UNITED STATES PATENT AND TRADEMARK OFFICE

10/542,540

Office Action Summary	Application No. 10/542,540	Applicant(s) ROHRIG, PETER	
	Examiner ROBERT J. HICKS	Art Unit 3781

DETAILED ACTION

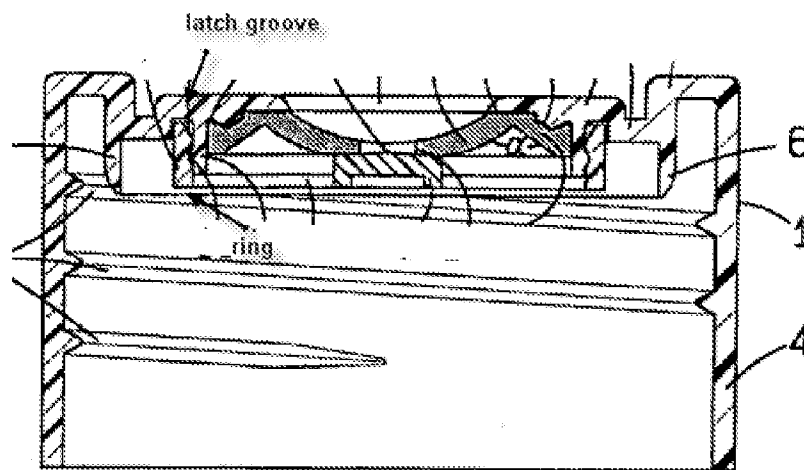
11. Regarding Claim 3, Suffa in view of Esposito discloses all the limitations substantially as claimed, as applied to claim 1 above; further, Suffa teaches the membrane support element (**Suffa**, 17) comprises a valve seat surface (**Suffa**, 16) corresponding with the inwardly curved shape of the membrane in the closed position (**Suffa**, Fig. 1).

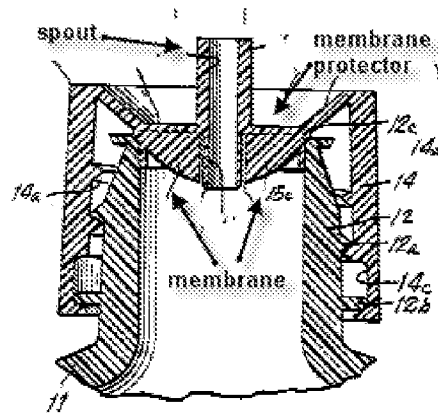
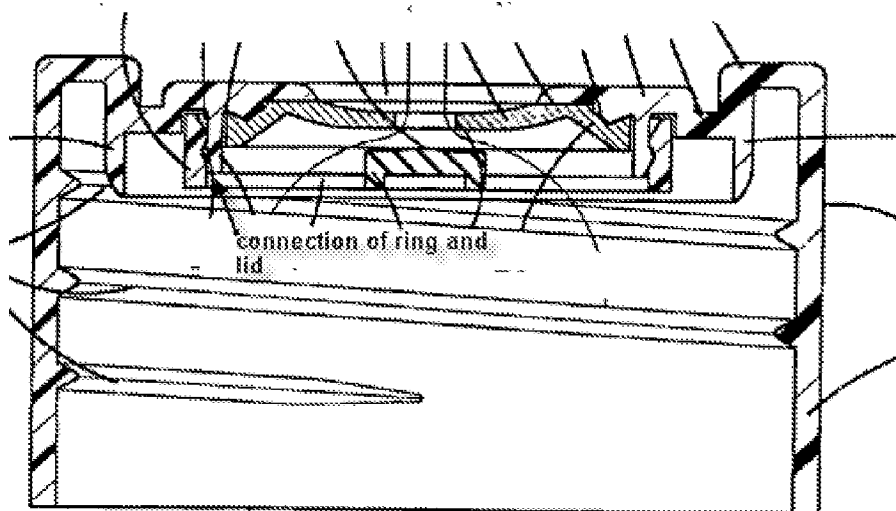
mouthpiece formed as a drinking spout (**Esposito**, 16) extends beyond the membrane, whereby an elevated drinking spout edge is formed as a membrane protection and spacer element (**Esposito**, Fig. 4).

15. Regarding Claim 11, Suffa in view of Esposito discloses all the limitations substantially as claimed, as applied to claim 1 above; further, Esposito discloses the drinking mouthpiece is made of an elastomer material (**Esposito**, 16, Fig. 4, Col. 2 Lines 13-21).

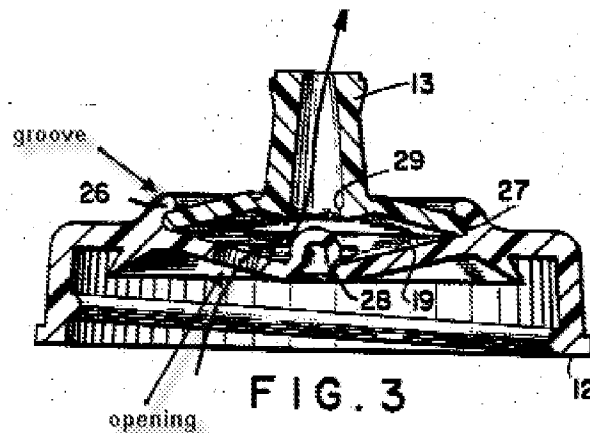
29. Regarding Claim 7, Suffa in view of Esposito in view of Meins discloses all the limitations substantially as claimed, as applied to claim 6 above; further, Suffa teaches the web (**Suffa**, 18) used to fasten the membrane support element is a plate with the

plain defined by the web in the direction of the longer axis of the drinking mouthpiece top view (**Suffa**, Fig. 2). A circle is a special type of ellipsis or oval.
